## Memo

To Jamie Sirl  
CC Renee Fraser-Smith, Caleb Clarke, Craig Sharman  
From Gustaaf Kikkert  
Reviewed by Eugene Vodjansky  
Date 23 July 2021  
Job No. 147090  
Job name Rotokauri North Development  
Subject Subcatchment ICMP – Stormwater Management Report

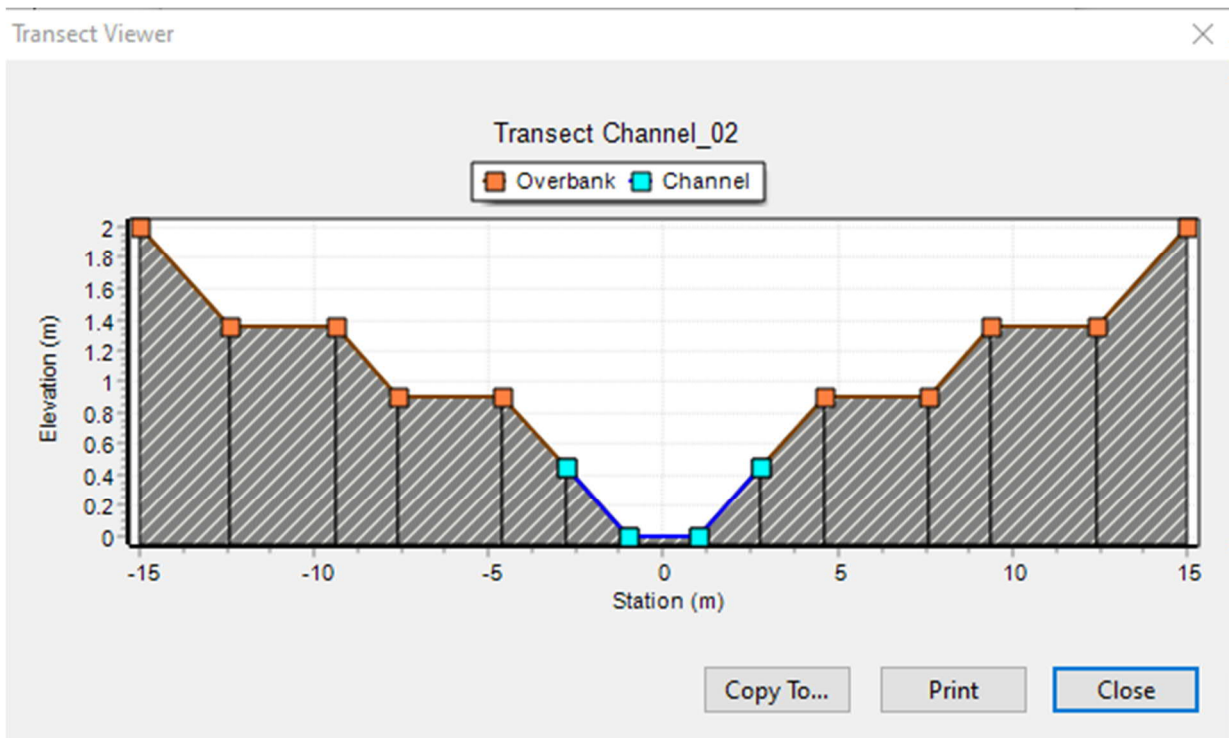
- Tailwater: The SSR doesn’t discuss tailwater conditions used on modelling. We can see that in the 2D model, the initial stored volume in the system was set to 2mm and assume this is just to kick start modelling. How was initial water level in the stream and wetlands accounted for in the model, or was the terrain model developed to sit above the permanent water level?

BBO reply: The outfall structures at Exelby Rd, SH39 and the Mangaheka wetlands control the flow out of the catchments. Due to the attenuation provided within the catchment, the water surface within the catchment will be higher than that downstream of the outfall structures, however it cannot be assumed to have a free outfall. Flow rates or elevation data were not available at any of the outfall locations for determining the tailwater condition. At Exelby Rd and SH39 crossings, a section of channel was added downstream of the culverts/weirs in the SWMM model. The channel ended at the outfall node. The tailwater conditions were obtained by giving the outfall node an appropriate invert level and setting the outfall type to Normal, causing a normal flow calculation for the channel to establish the tailwater. The flow conditions at the outfall point are then calculated based on the upstream channel. For the Mangaheka catchments, a part of the Mangaheka stream was included in the SWMM model to yield appropriate tailwater conditions. The size of the culvert crossing Te Kowhai Rd East was unknown; hence the model was calibrated using elevation data from the report "Mangaheka Integrated Catchment Management Plan – Stormwater 1D Modelling Report" which is an attachment to the Mangaheka ICMP. For the Rotokauri South catchment, the water is conveyed to wetland G8 which is not part of the subcatchment ICMP and hence no tailwater modelling was carried out.

As part of the stormwater management plan, the existing stream will be re-established and will have functional floodplains. The details of the re-established streams will be worked out as part of detailed design. In addition, the initial water levels in the streams are currently not known and hence these were not included in the 1D and 2D models. The cross-sectional profiles used in the 1D and 2D models were instead simplified approximations of the final cross-sections and therefore did not explicitly include the part of the stream that has a permanent flow. For the large storm-events modelled, the details of the stream have little impact on the flow behaviour.

For the wetlands, the invert levels used in the models were at the permanent water level.

The report has been updated to clarify the above.

SWMM model Ohote stream simplified cross-section.

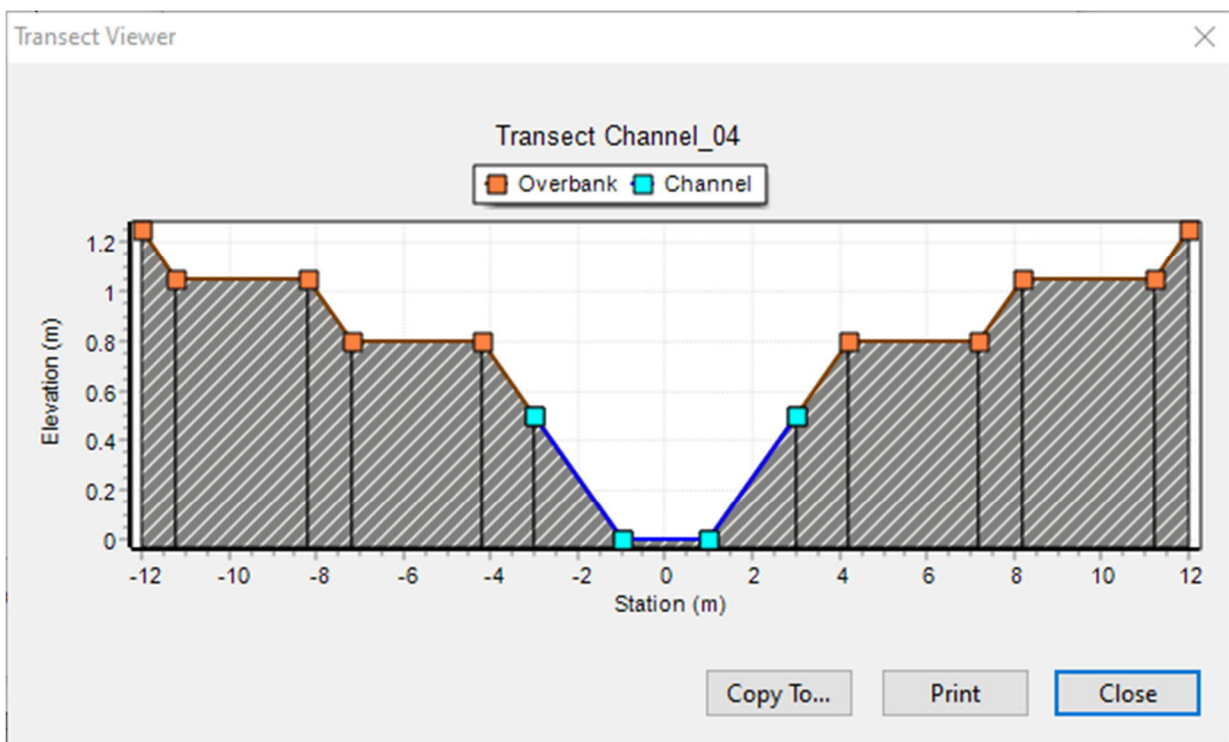
- Cross sections: Please provide stream cross sections and the total width of land required to contain a stream channel that conveys the required flow.

As mentioned above in a reply to a previous comment, the cross-sectional profiles used in the 1D and 2D models were simplified approximations of the final cross-sections to be designed as part of detailed design. The proposed batter slopes are 1:4 (V:H) and an example cross-section is shown below for the Ohote and Te Otamanui streams. Away from the wetlands and based on the latest lay-out of the development, the width of land available for the stream cross-section along the Ohote stream varies between 30m and 50m. For the Te Otamanui stream this varies between 27m and 53m.

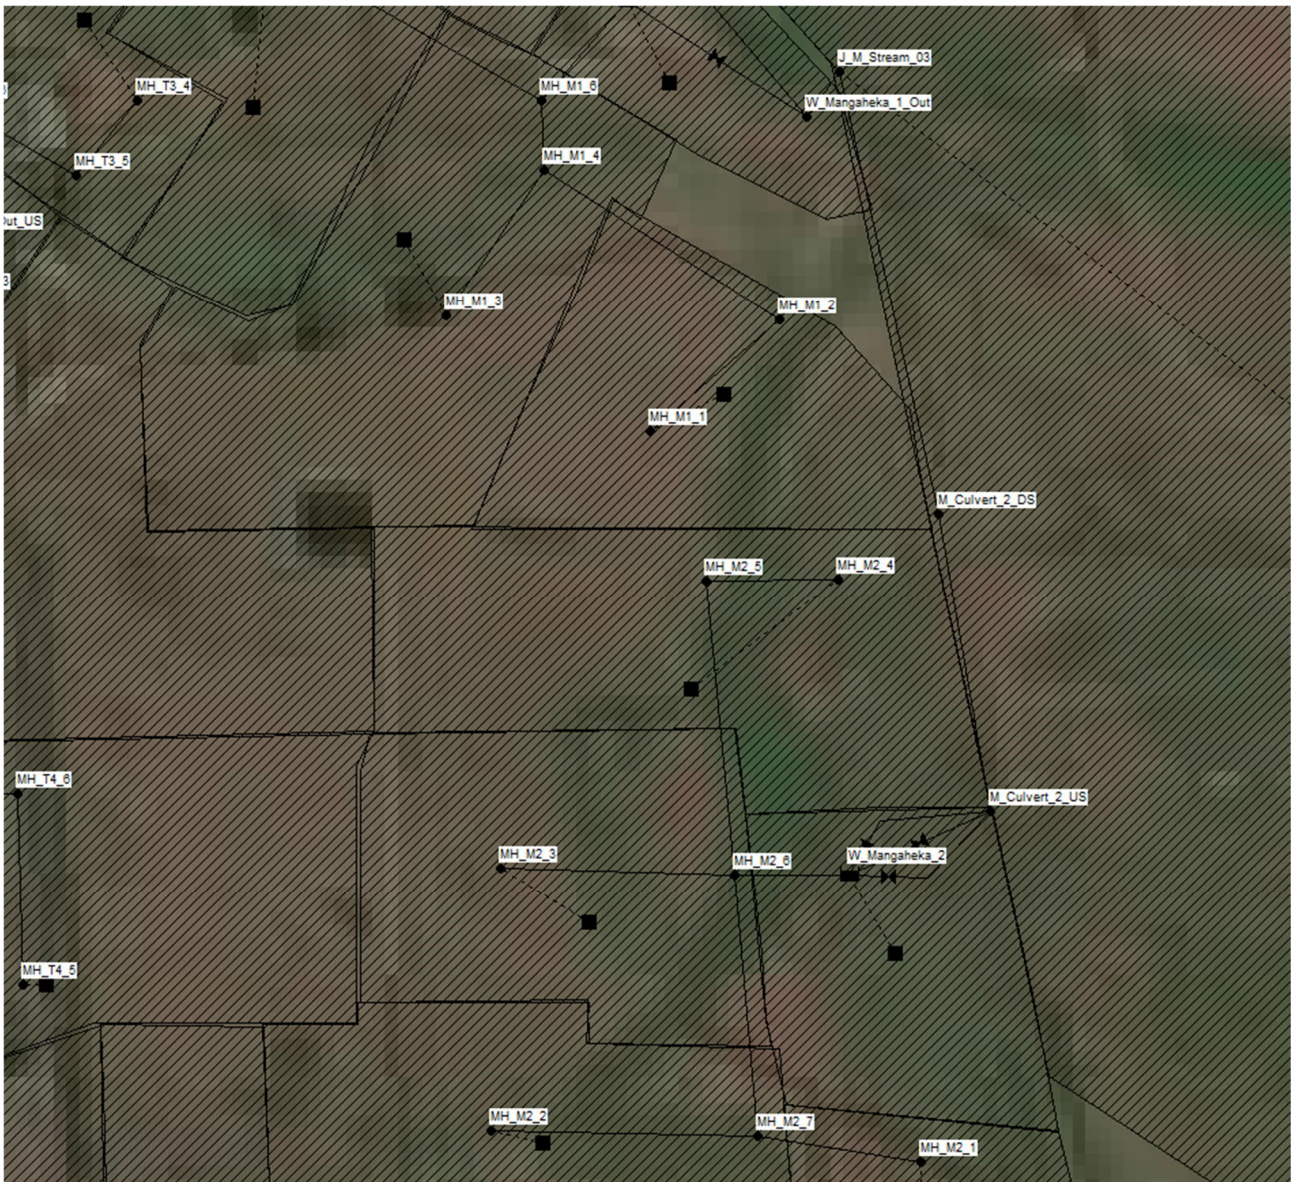
- Wetlands: It seems that there is one wetland missing from the design. Has the wetland named Mangaheka 2A (1.6ha) in the concept layout been modelled? The storage node at that location in the SWMM model layout image is named W Rotokauri South 1, but a wetland named that isn't on the concept layout plan. Additionally, although difficult to see on the SWMM model layout image, it doesn't look like this network (J148 down to MH S1 4) is connected to the swale between Mangaheka W1 and the culvert. It is mentioned that and that Mangaheka 2A is connected via a pipe – is that intended to go along Burbush Road? Can this be conveyed in an open channel instead?

BBO reply: Initially major sub-catchment Mangaheka 2 was directed southward to discharge in the Rotokauri South drain (at this time this major sub-catchment was referred to as Rotokauri South 1 and the current Rotokauri South 1 was referred to as Rotokauri South 2). During our discussion with Beca about the boundaries of the major sub-catchments, it became clear that it was not possible to discharge Mangaheka 2 southward and instead had to be discharged northward into the Mangaheka. The map of the nodes included in the SWMM model forwarded to Morphum on 7/07/2021 was of an earlier copy of the SWMM model before this change was made while the results in the Appendix A were from the latest copy. This has caused the confusion as indicated by the reviewer.

An updated copy of the map, focused on the Mangaheka 2 sub-catchment is shown below. This includes Wetland Mangaheka 2 and the pipeline that connects the outfall structure of the wetland with swale upstream of the discharge point into the Mangaheka. It may be possible to construct this pipeline as an open channel instead for at least part of its length (it also has to cross two major roads, note that the pipeline follows the minor north-south arterial, not Burbush Rd). Options will be investigated as part of detailed design.

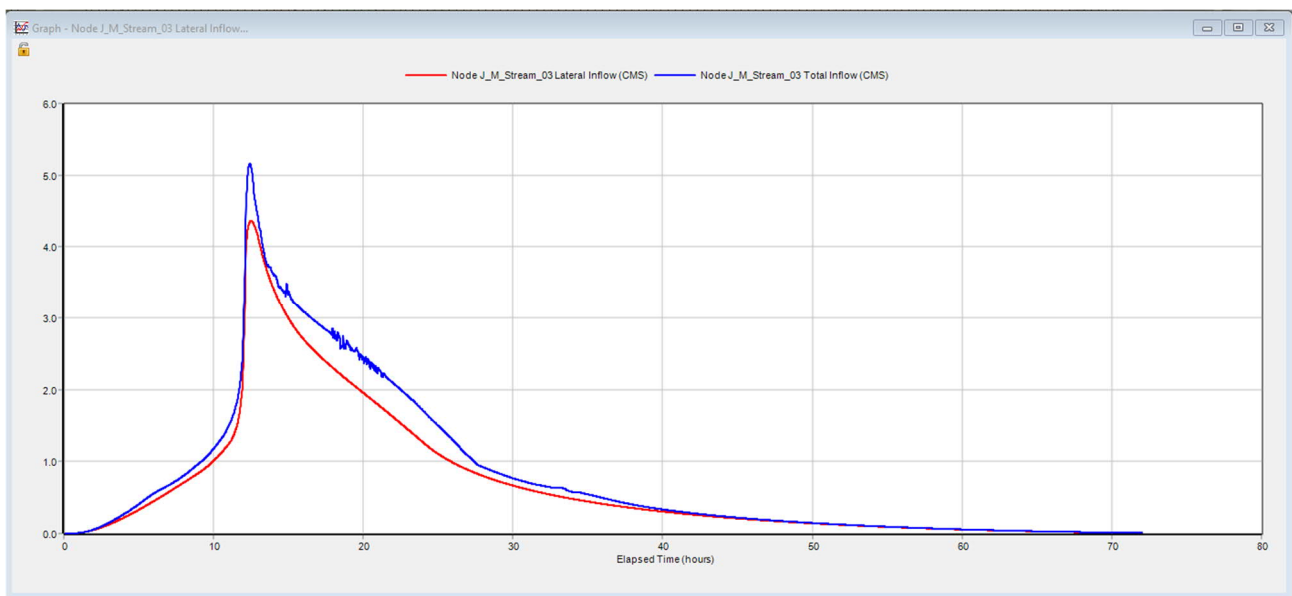
- Peak flow: In Section 8.2 of the ICMP, Table 12 (and SSR Table 5-1) the average flows from SWMM tabular report were listed for Mangaheka instead of the max flow, eg. at Mangaheka\_Out node the peak flow was 3.04 m<sup>3</sup>/s and average of 0.82 m<sup>3</sup>/s was adopted into the Tables. Please clarify why the average flow was included in the report summary, rather than the peak.

Mangaheka\_Out is the node downstream of Te Kowhai Rd East and the end of the routed model that begins at the Mangaheka minor subcatchments. Please note that this is not the outflow from the combined Mangaheka 1 and Mangaheka 2 wetlands. This happens at node J\_M\_Stream\_03 (as seen in the updated map of the SWMM model presented above). The discharge flow rate is the difference between the total flow rate at this node minus the lateral inflow from the Mangaheka\_Upstream sub-catchment. Using the max flow rate information in Appendix A (p110) would give a discharge estimate for the Mangaheka wetlands of 0.793m<sup>3</sup>/s, however the peaks of the flow rates from the sub-catchment and wetlands do not align. Instead, the time-series from the total flow rates and lateral flow rates were obtained as shown below. Subtracting the two time-series and finding the maximum difference yielded a value of 0.8146m<sup>3</sup>/s which is the value as presented in Table 5-1.
